**DOCUMENT 00 90 00
ADDENDUM**

ADDENDUM NO. [2] Date: October 10, 2019

**RE: LANESBORO PUBLIC SCHOOLS
 ADDITION AND REMODEL REBID
 100 KIRKWOOD ST EAST
 LANESBORO, MN 55949
 HSR 18063**

**FROM: HSR Associates, Inc
 100 Milwaukee Street
 La Crosse, WI 54603
 (608) 784-1830**

E101P

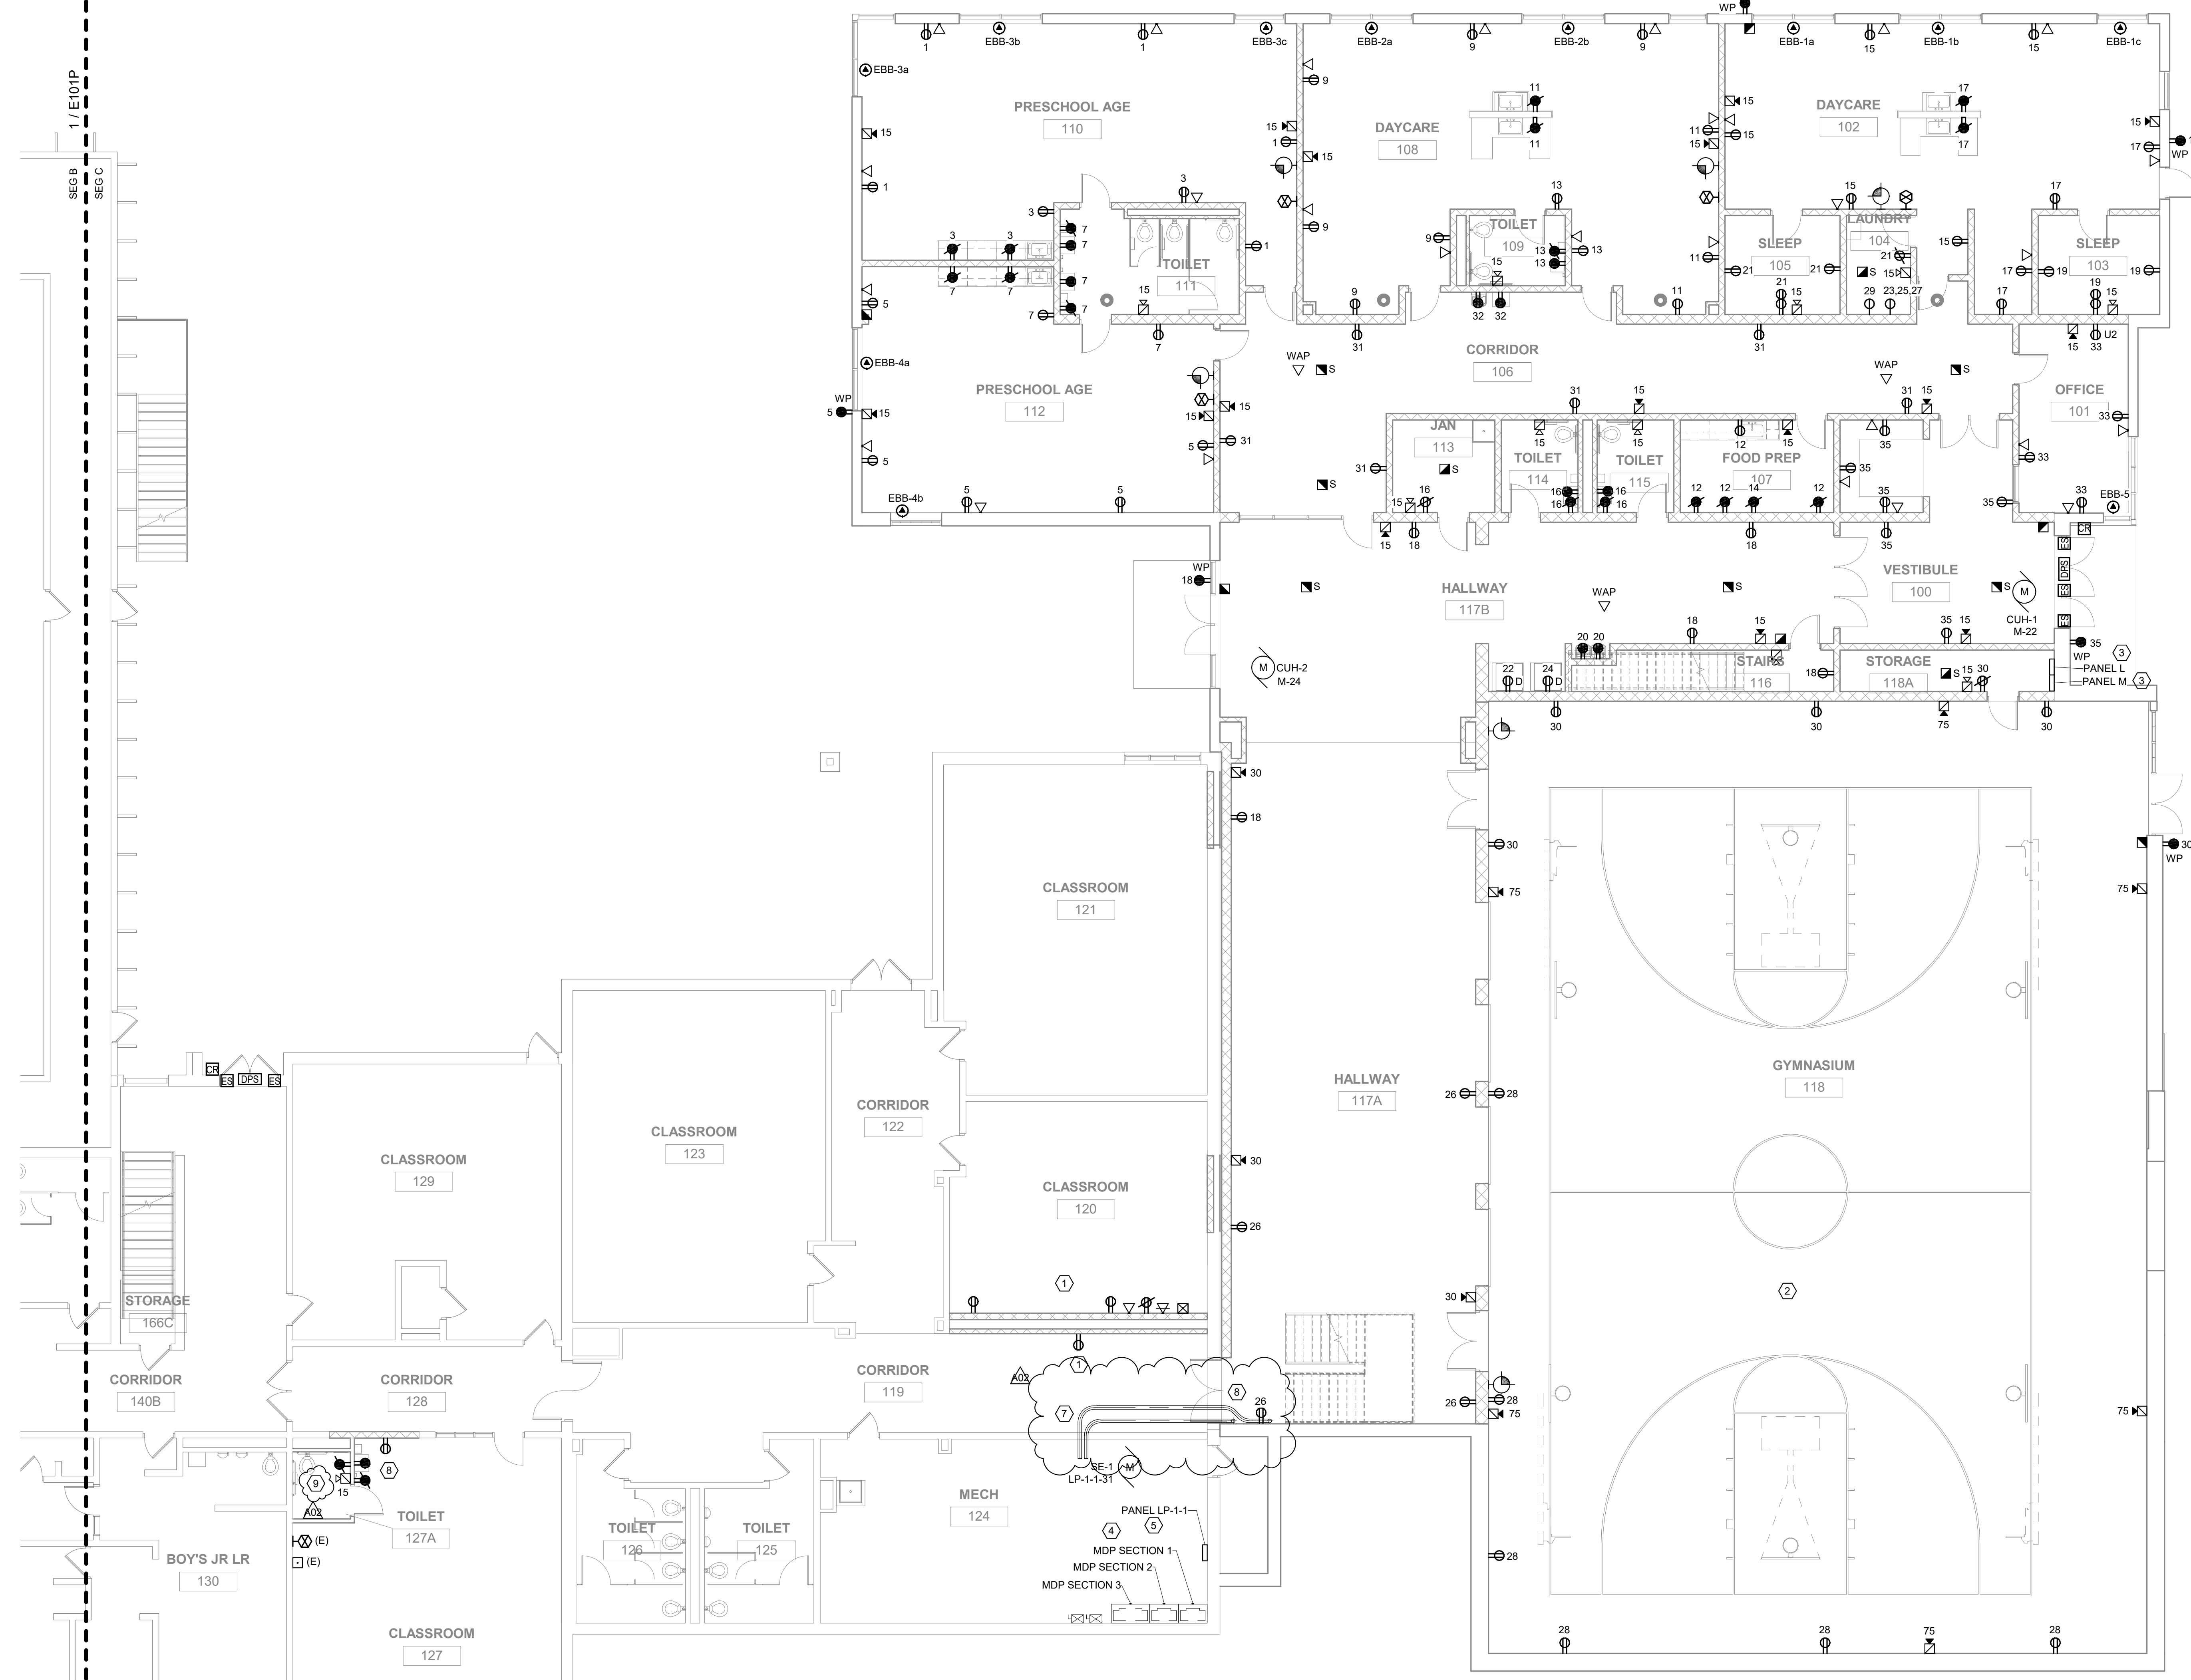
- a. Revisions clouded on Drawing
 - b. Revise power and systems devices per architectural changes, as shown.
58. Sheet E102P – LOWER LEVEL – SEG C – POWER/SYSTEMS 30 x 42 attached hereto

Sheet Title: **LOWER LEVEL - SEG C - POWER/SYSTEMS**

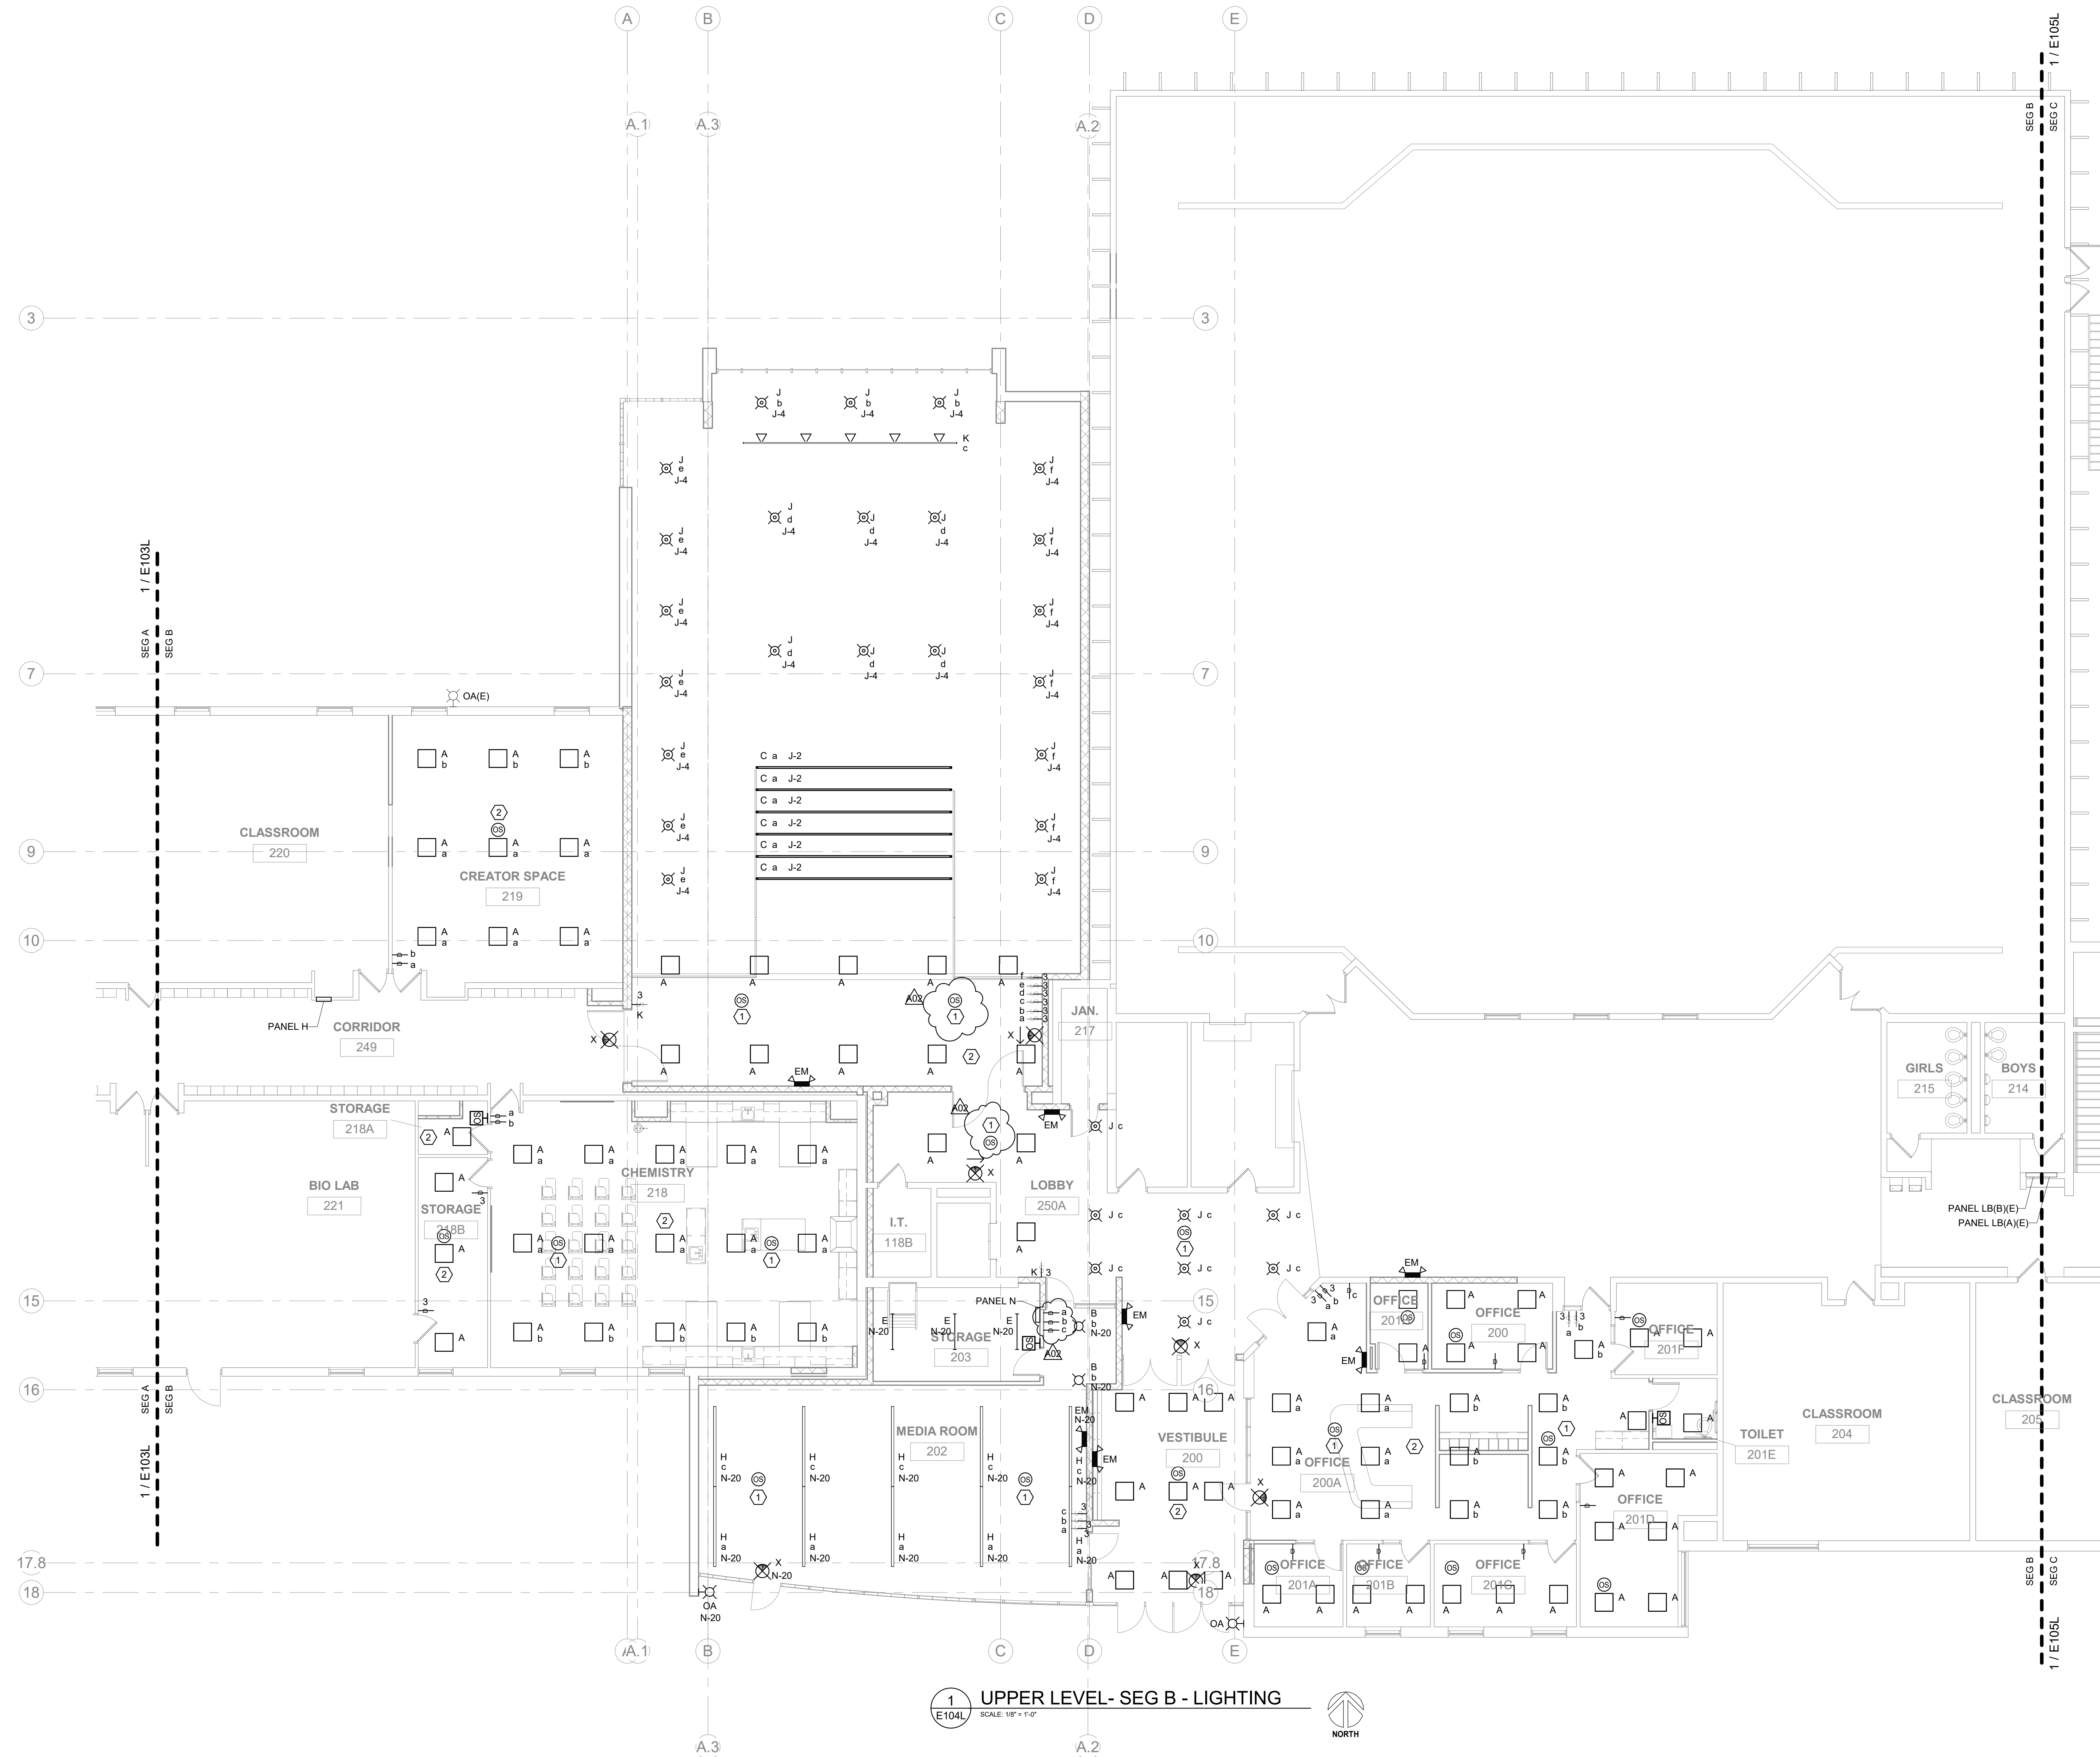
- a. Revisions clouded on Drawing
 - b. Revise keyed note 7 to clarify scope of work for solar/pv conduits and routing, as shown.
 - c. Add keyed note 8 to clarify scope of work for solar/pv conduits and routing, as shown.

E104L

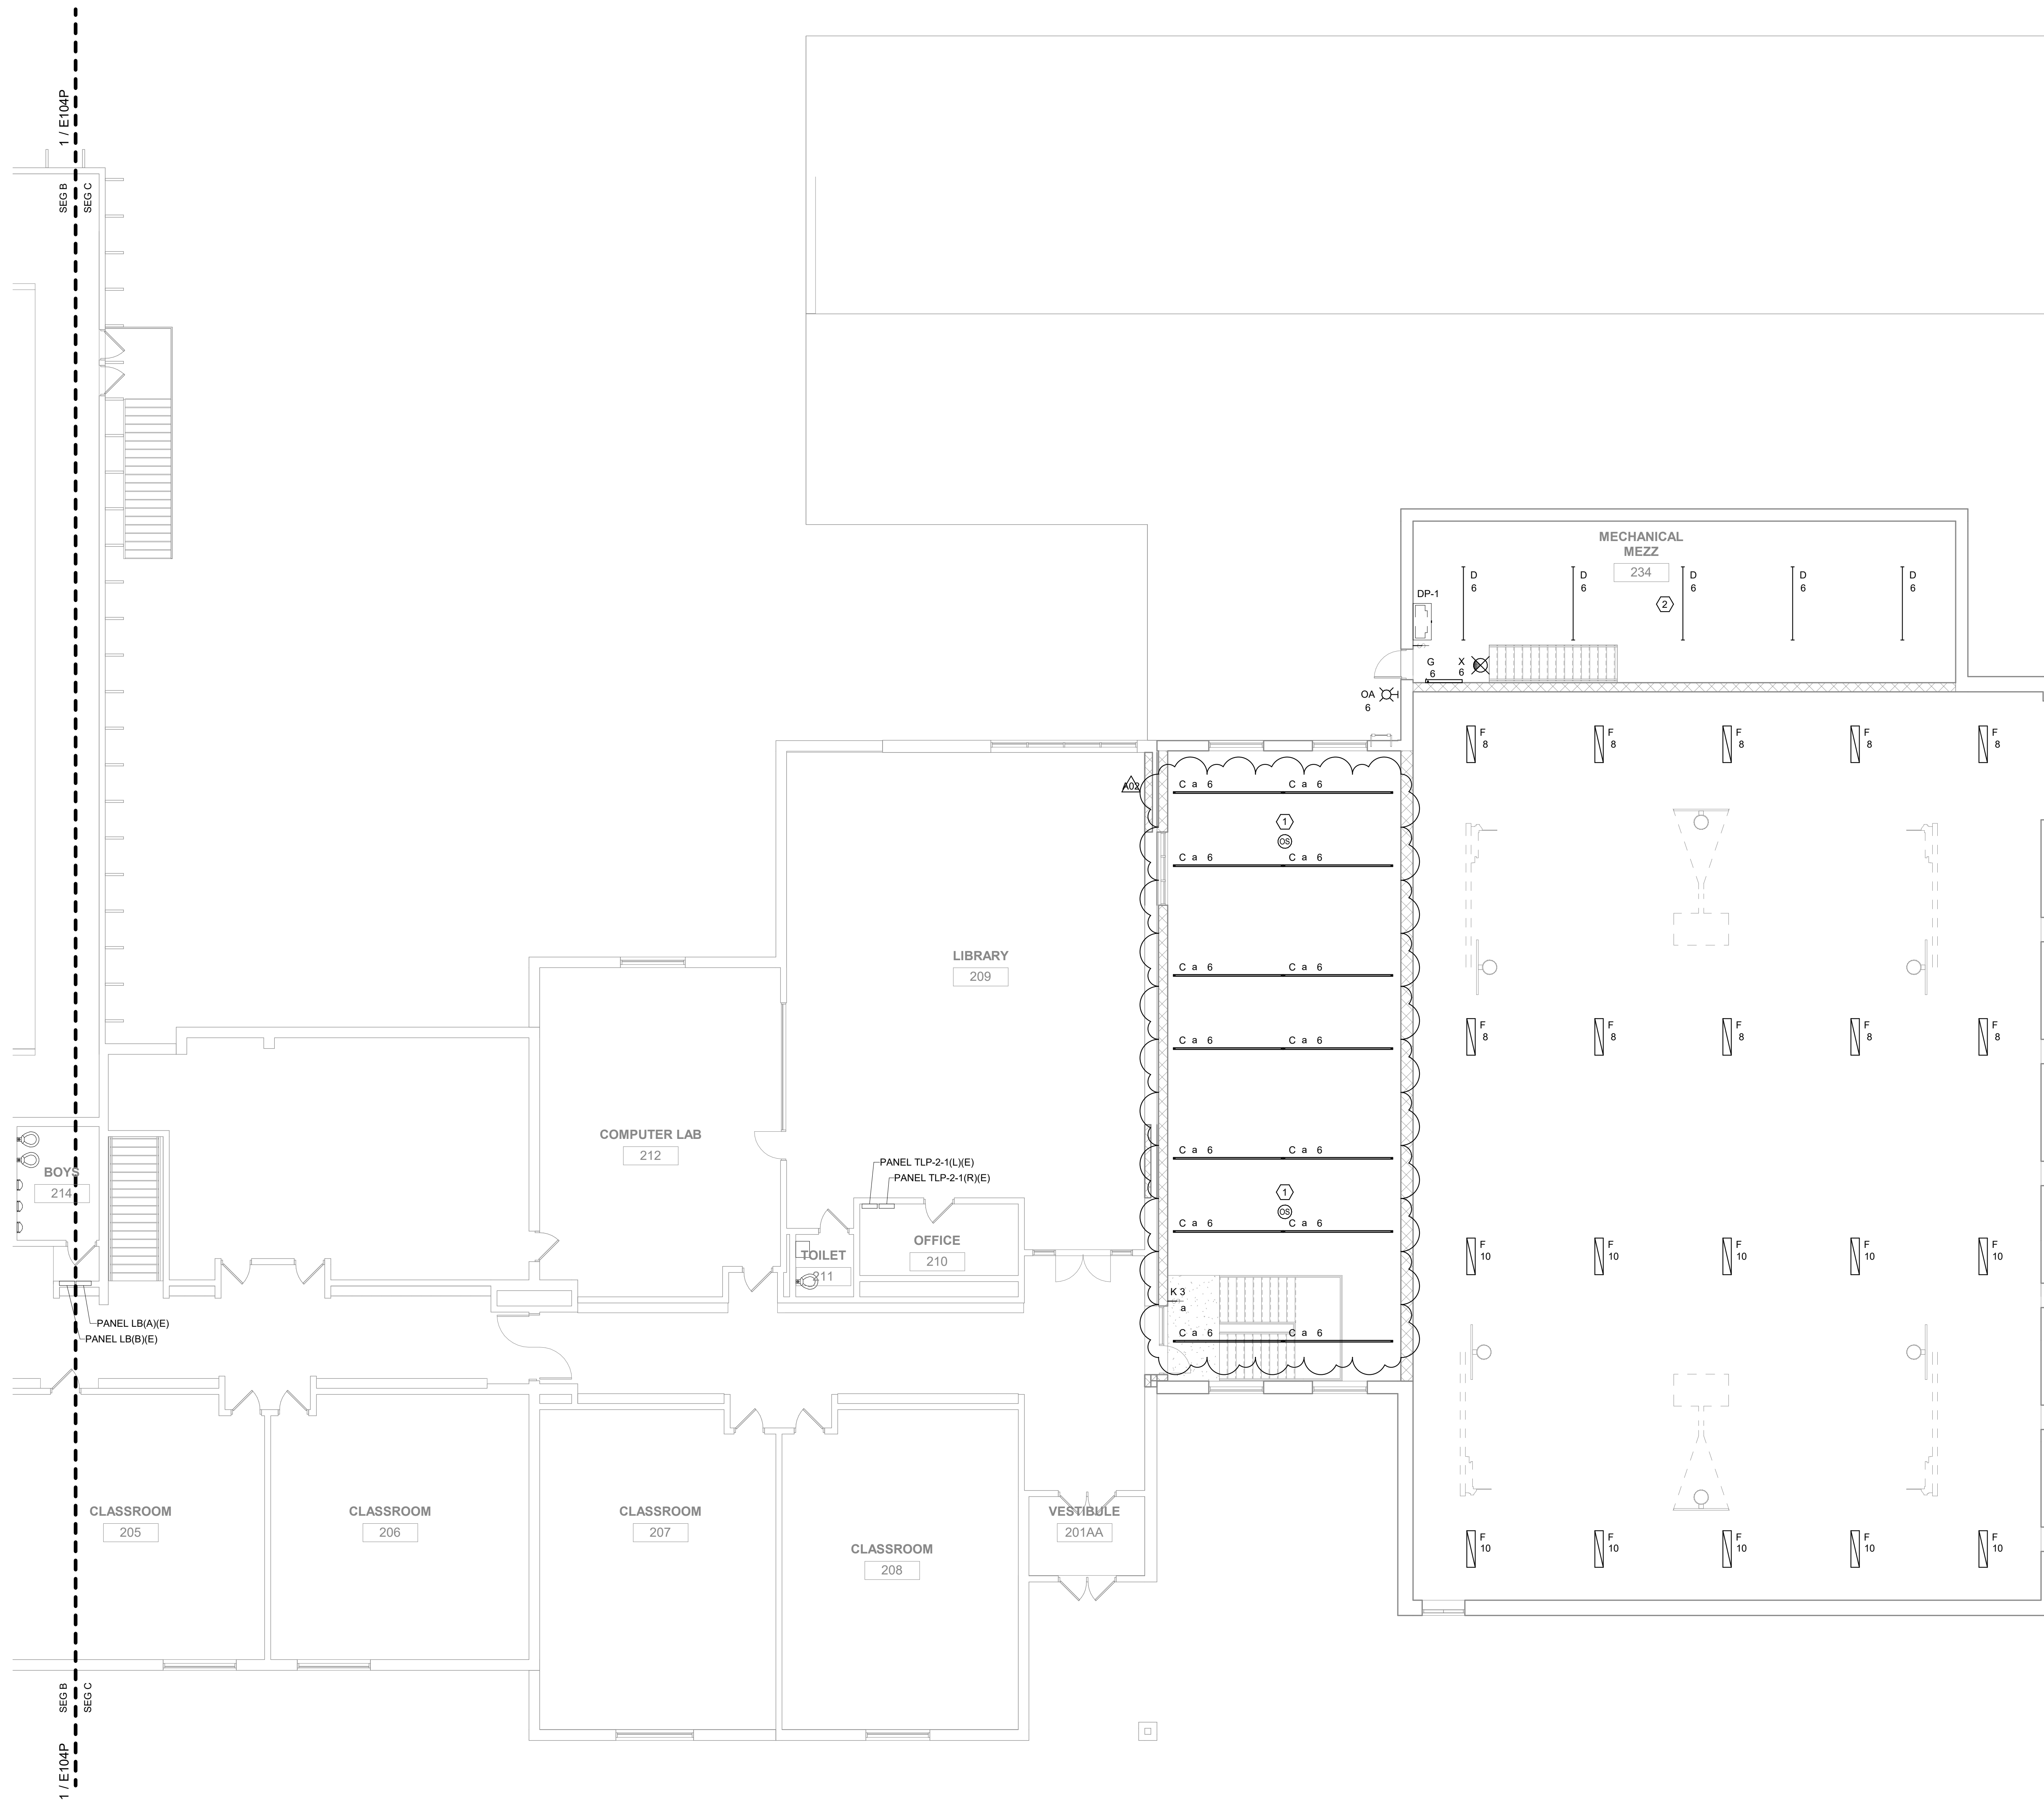
59. Sheet E104L – UPPER LEVEL - SEG B – LIGHTING 30 x 42 attached hereto
 - a. Revisions clouded on Drawing
 - b. Revise lighting and lighting control devices per architectural changes, as shown.
